One-hundred-and-fifty-first session Geneva, 22 – 25 June 2010 Item 4.2.2 of the provisional agenda 1958 Agreement - Consideration of draft amendments to existing Regulations

Proposal for Supplement 5 to the 11 series of amendments to Regulation No. 13 (Heavy vehicles braking)

Submitted by the Working Party on Brakes and Running Gear *

"Figure 5A: MECHANICAL-TRANSMISSION BRAKING SYSTEM (See paragraph 2.3. of this annex)

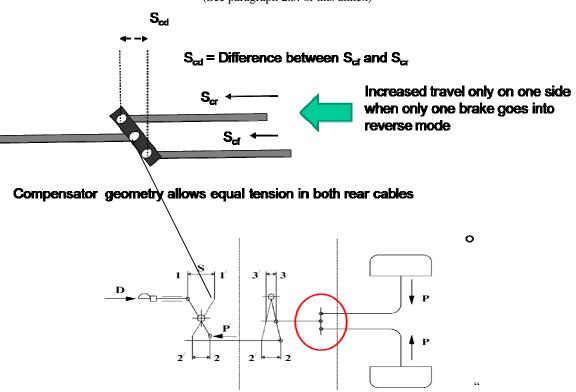
- "2. SYMBOLS AND DEFINITIONS
- 2.3.10. s_{cf} : Rear cable or rod travel at compensator when brakes operate in orward direction 1
- 2.3.11. s_{cr} : Rear cable or rod travel at compensator when brakes operate in rearward direction 1
- 2.3.12. s_{cd} : Differential travel at compensator when only one brake operates in the forward direction and the other in the reverse direction ¹

Where: $s_{cd} = s_{cr} - s_{cf}$ (see figure 5A Appendix 1)"

Annex 12, Appendix 1, insert a new figure 5A, to read:

- "8. SIMULATED GRADIENT PARKING BRAKE FORCE DIFFERENTIAL
- 8.1. Calculation method
- 8.1.1. The pivot points in the compensator shall lie in a straight line with the park brake at the rest position.

All compensator pivots to be in-line

Alternative arrangements can be used, if they provide equal tension in both rear cables, even when there are differences in travel between the rear cables.

8.1.2. Drawing details are to be provided to demonstrate that the compensator articulation is sufficient to ensure equal cable tension is applied to each of the rear cables. The compensator needs to have sufficient distance across the width to facilitate the differential travels left to right. The jaws of the yokes also need to be deep enough relative to their width to make sure that they do not prevent articulation when the compensator is at an angle.

Differential travel at compensator (s_{cd}) shall be derived from:

$$s_{cd} \ge 1.2 \cdot (S_{cr} - S_{c'})$$
